AGENDA ITEM SUMMARY / STAFF REPORT
FLORENCE PLANNING COMMISSION

ITEM TITLE: *PC 23 01 DR 01 – Lane Community College Site Lighting Exception*

City of Florence—Planning Commission
FINDINGS OF FACT
Design Review
Exhibit “A”

Application: PC 23 01 DR 01 Lane Community College Lighting Exception

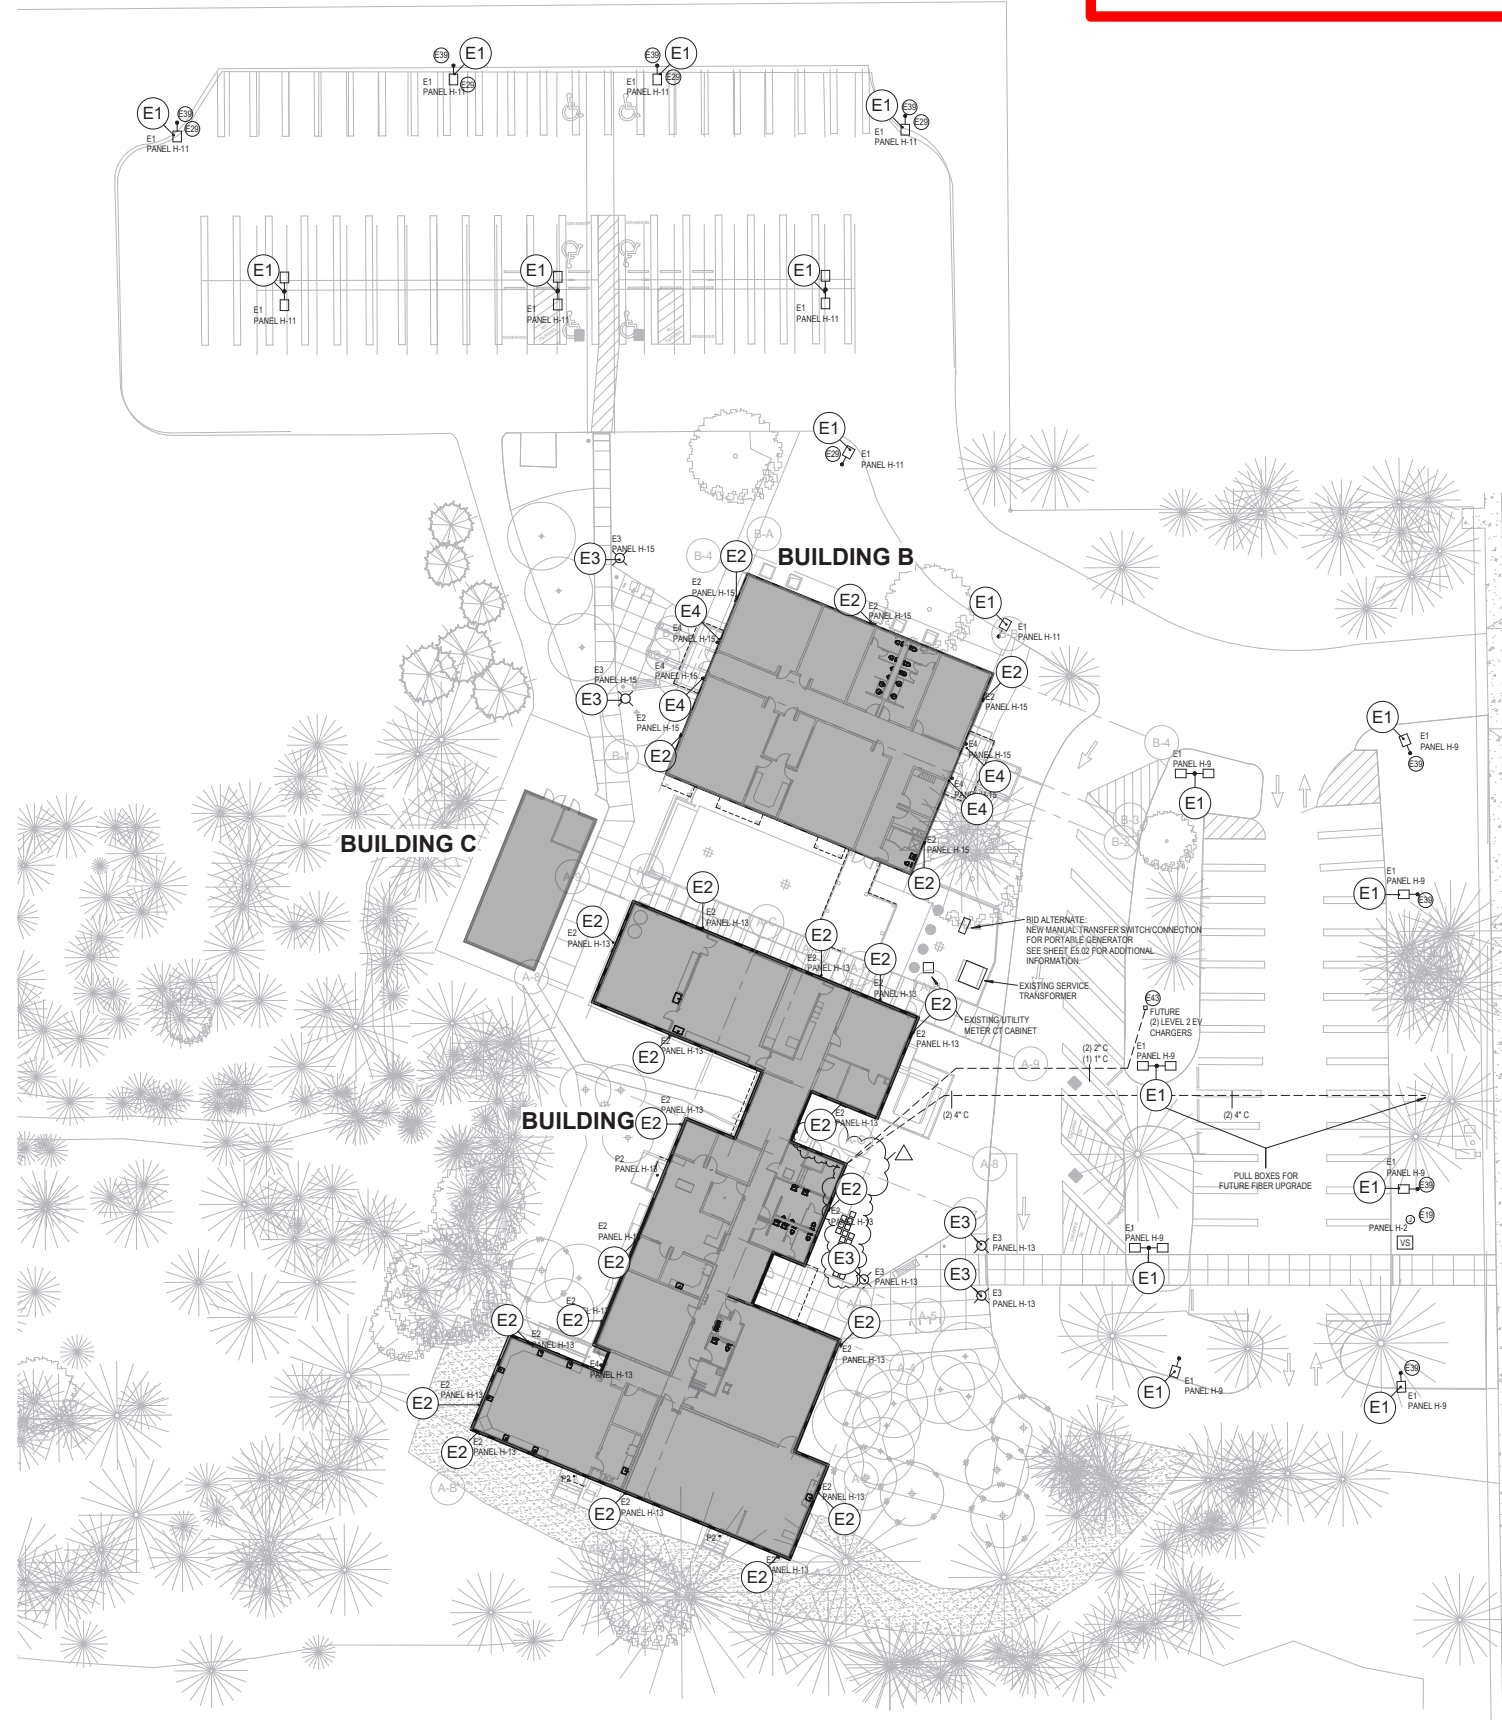
The applicant submitted a photometric site plan with the lumen output for the proposed development and cutsheets for the proposed fixtures. Parking lot, building, and bollard lighting are proposed. Key note E29 states the parking lot fixtures will be mounted on existing poles and bases.

The application includes cutsheets for four proposed luminaires. The parking lot (E1) is a full cut-off fixture and meets this criterion.

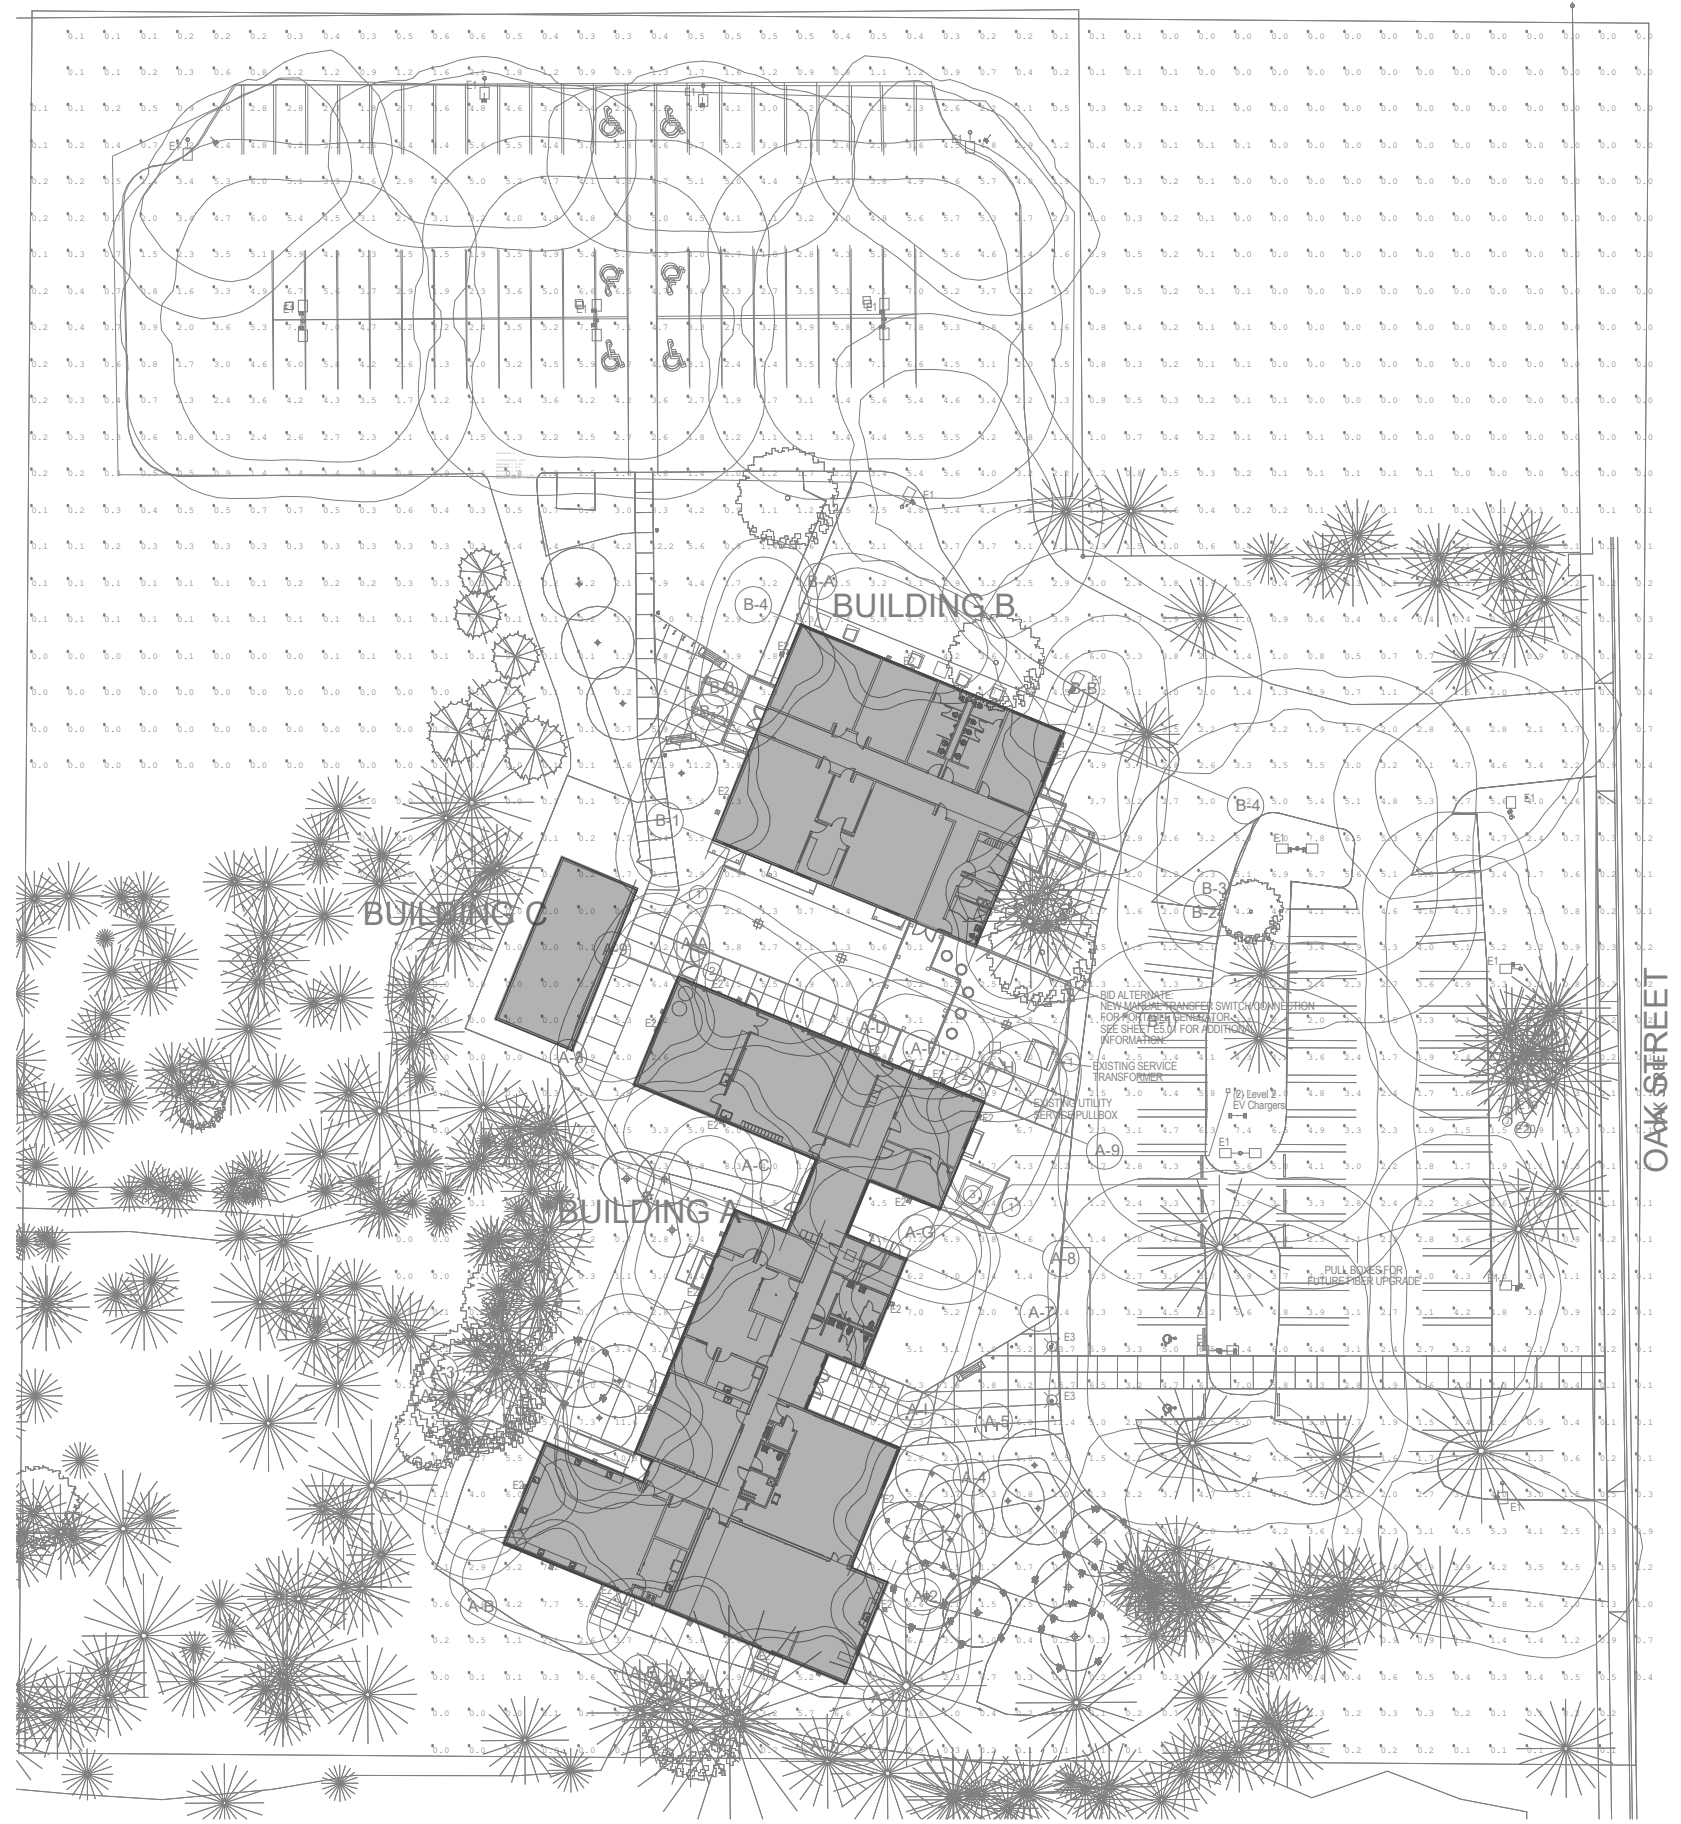
The photometric site plan includes illumination levels shown on the entirety of the site. The parking spaces and internal walkways have a maximum foot candle of 8.2 and a minimum of 1.1 within the parking lot. There are many points when the illumination is greater than 5-foot candles over parking spaces and a few places greater than 5 ftc over walkways. In Condition 23 of the staff review the applicant was required to either modify the lighting fixtures or illumination levels to achieve the requirements of 10-37-4-B or receive approval from the Design Review Board to not meet the minimum footcandles. The applicant has proposed to request an exception. The plans appear to indicate that the illumination level may be adjusted on the light fixture. Of note the code permits greater than 5-foot candles and not more than 7-foot candles and less than 2-foot candles.

Nowhere in any of the relevant documents can we find any justification for an exception to the City Code. The most relevant information is this statement by the applicant: "At the time of the design review approval, site lighting has already been purchased and are being delivered to the site." As we understand that statement, they ordered lighting fixtures before they received final approval and now they expect the Planning Commission to grant an exception to the City Code.

The Code is very clear on the minimum and maximum allowable site illumination levels. This project is in the middle of a High Density Residential area. Virtually all light-shielding vegetation was removed from the site as part of this project. Twenty-year-old rhododendrons that stood 8-10' tall and wax myrtles of similar size were ripped out and replaced with 18" ferns and other plantings that will never provide shielding from the bright lights in the parking lot and on the facade of the buildings. The pollution from these light fixtures directly affects all neighboring properties — those lights shine directly into surrounding homes.
